Historic Preservation Design Review

May 27, 2010

HP-10-10, 13 N. Main St. (City)

Request: Design review approval for proposed façade restoration/renovations to include: new storefront, restoration of damaged molding using precast concrete; reopening closed window openings and installing new windows, and repairing existing precast inlay to match existing.

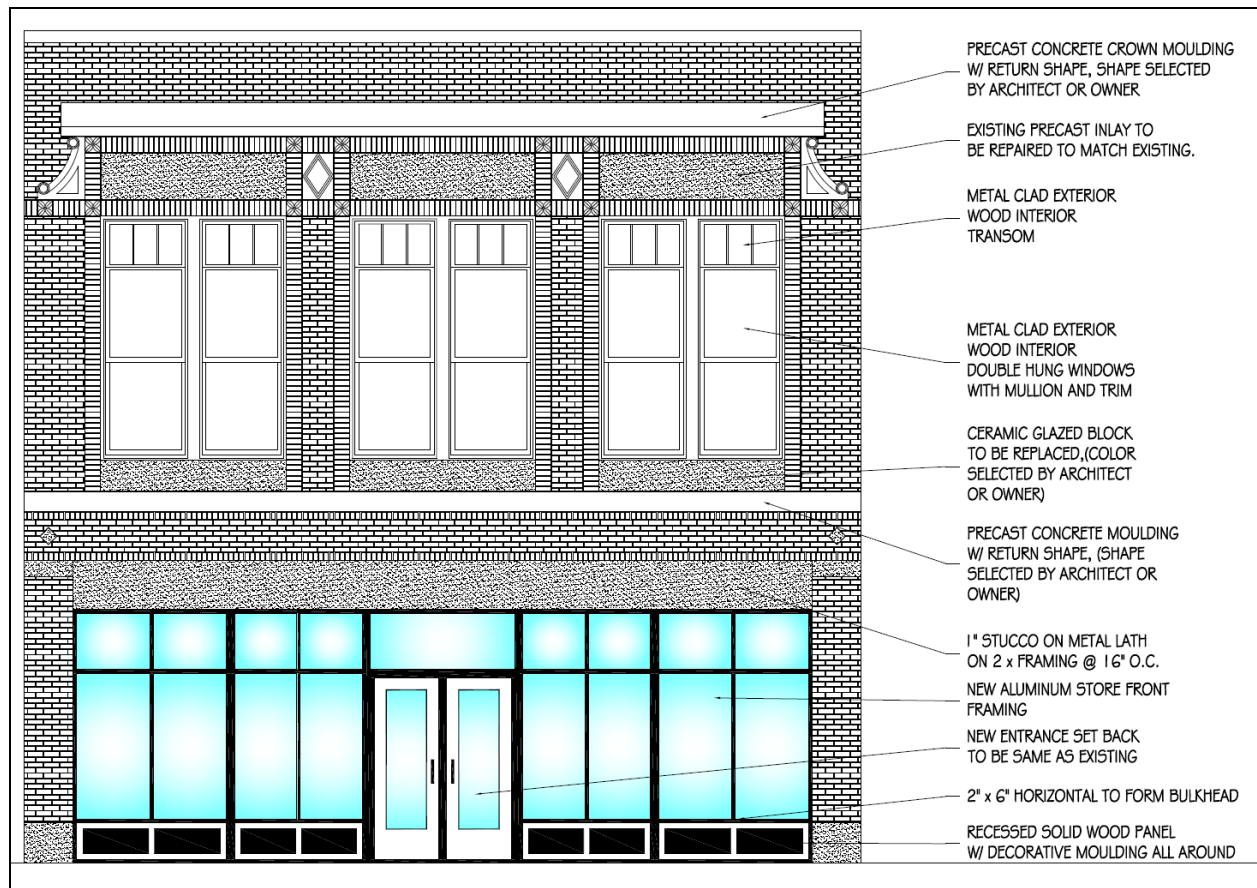
As shown in the red box above, the existing storefront is not historically appropriate. There is also indication that the second story windows were bricked over prior to the installation of the metal veneer.

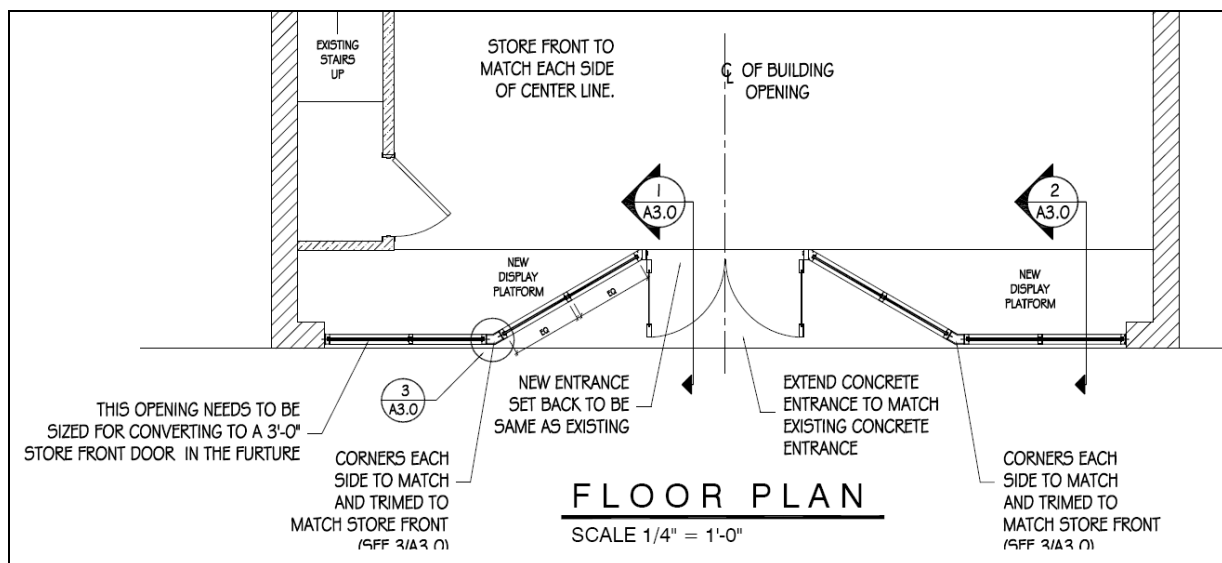
There is no original transom remaining. The new storefront will have transoms as shown in the elevation on page 3 of this report.

The roof cornice has been destroyed. As shown in the proposal on page 3 of this report, the new roof cornice referred to as crown molding in the elevation, will be based off of the remaining ghosting of the building.

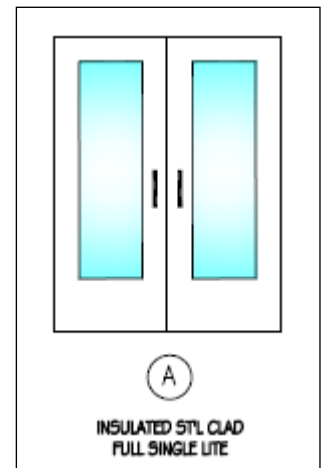
The building has no original doors. The proposed replacement doors that are part of the storefront will be insulated steel clad doors that can be painted as shown to the right.
